APPLICATION FOR PERMISSION
UNDER SECTION 16 OF
THE TOWN PLANNING ORDINANCE
(CAP. 131)

(a) Proposed use(s)/development
擬議用途/發展Proposed Temporary Place of Recreation,
Sports or Culture (Hobby Farm) and Land Filling
擬議臨時康體文娛場所(休閒農場)及填土工程

寄件者: [REDACTED]
寄件日期: 2024年03月22日星期五 16:17
收件者: Margaret Wai See SZETO/PLAND
副本: tpbpd/PLAND; [REDACTED]
主旨: 有關A/YL-SK/359意見回覆
附件: SK359_Plan.pdf; Temporary Drainage Proposal for A_YL-SK_359.pdf
類別: Internet Email

Response to Comments on Temporary Drainage Proposal

Appendix C -
Proposed Drainage Plan

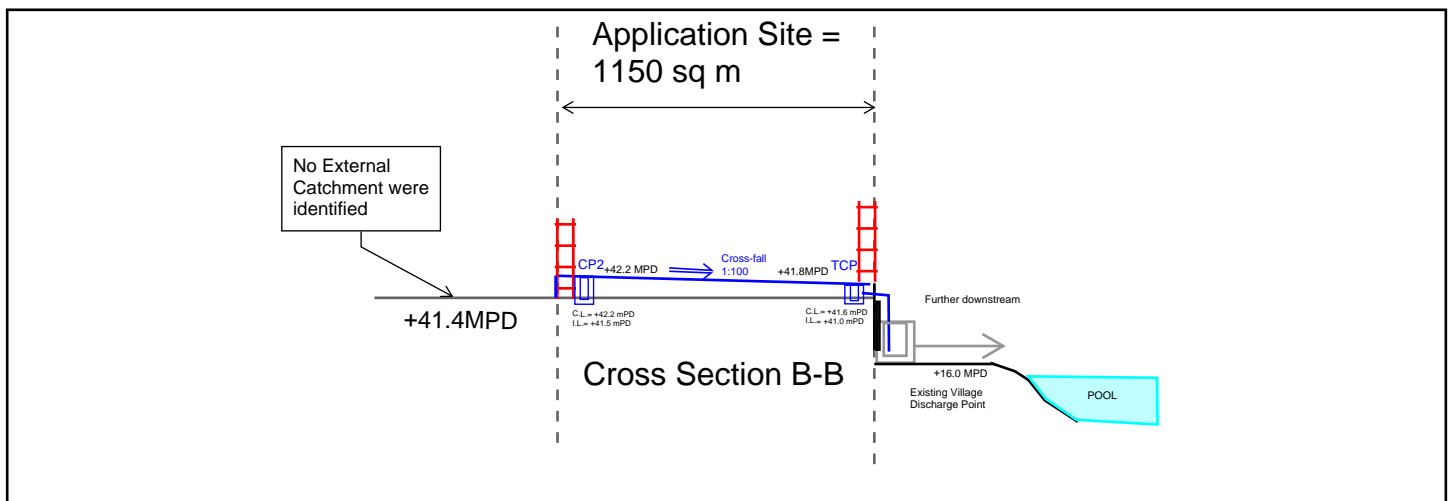
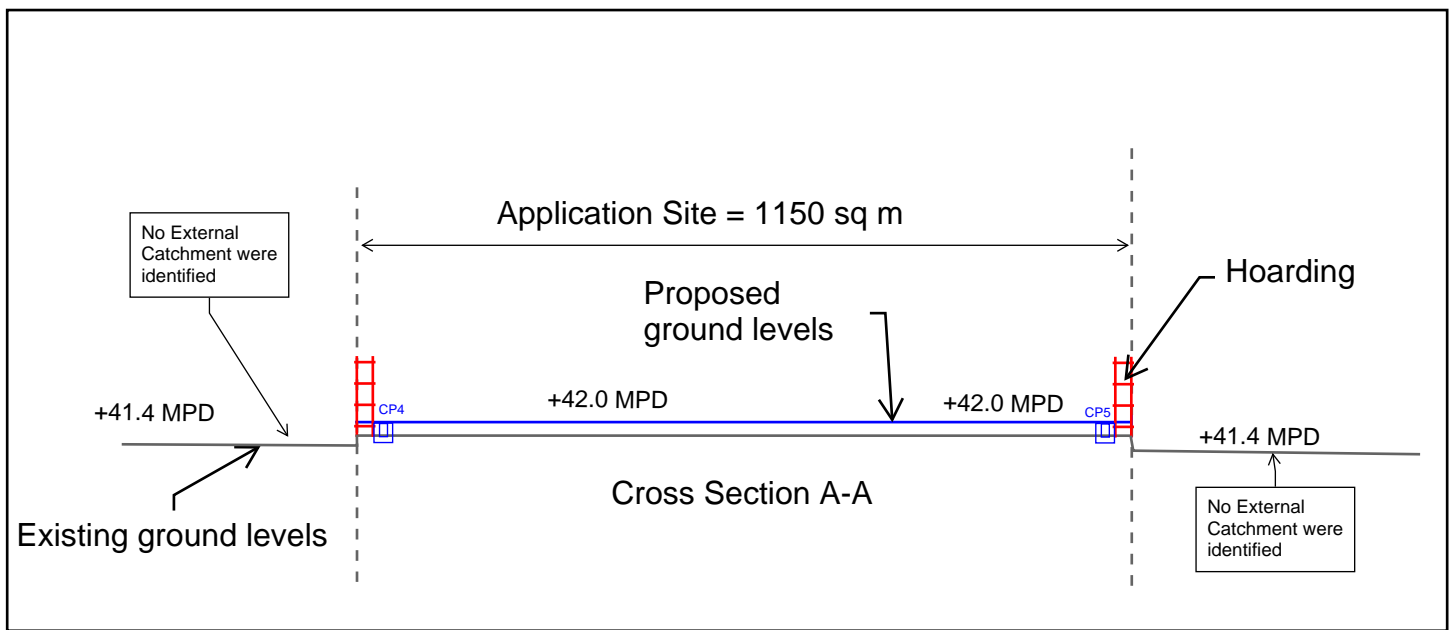
5.	Please indicate clearly the full alignment of the discharge path from the application site all the way down to the ultimate discharge point (e.g. a well-established stream course/public drainage system).	For the full alignment of the discharge path from the application site, please refer to the Appendix C – Proposed drainage plan.

6.	The gradients of the proposed U-channels should be shown on the drainage plan,	Noted and provided. Please refer to Appendix C - Proposed drainage plan.

7.	The proposal should indicate how the runoff (the flow direction) within the site would be discharged to the proposed u-channel.	Noted and provided. Please refer to Appendix C - Proposed drainage plan.

9.	Cross sections showing the existing and proposed ground levels of the captioned site with respect to the adjacent areas should be given.	Noted and provided. Please refer to Appendix C - Proposed drainage plan.

10.	Sand trap or provision alike should be provided before the collected runoff is discharged to the public drainage facilities.	Noted. Terminate catchpit with Sand traps is to be provided before discharging to the downstream village drainage facilities, to prevent blockages and for regular maintenance purpose. Please refer to Appendix C - Proposed drainage plan.

- (i) the proposed site formation works with revised ground level to +42.0 mPD will affect the overland flow from the adjacent lands. Please review;

- (ii) according to the paragraph 4.1.3 of the drainage proposal, the ground to the east, south and north of the application site is generally higher. Since the overland flow from the adjacent lands shall be probably intercepted, external catchment shall be considered in the calculation. Please provide a plan showing the extent of the external catchment area considered in the hydraulic calculation for our review;

- (iii) the ground to the west of the application site is generally lower. Please review the level at cross section A-A accordingly;
- (iv) please provide the connection details from the terminal catchpit to the existing village drain and advise the size, gradient and invert level of the discharge pipe/channel on the drainage plan. Please also demonstrate with hydraulic calculation that the proposed drainage facilities are adequate to collect, convey and discharge the surface runoff accrued on the application site and the overland flow intercepted from the adjacent lands;

- (vi) please provide site photos to demonstrate the presence of the ultimate discharge point (pond, etc.) and existing condition;
- (vii) catchpit(s) should be provided at all changes in direction and at intersection. Please review;

- (viii) the cover levels and invert levels of the proposed u-channels, catchpits/sand traps should be shown on the drainage plan;
- (ix) adequate opening should be provided at walls or hoarding are/to be erected or laid along the site boundary to intercept the existing overland flow passing through the site. Please provide its details for comments;
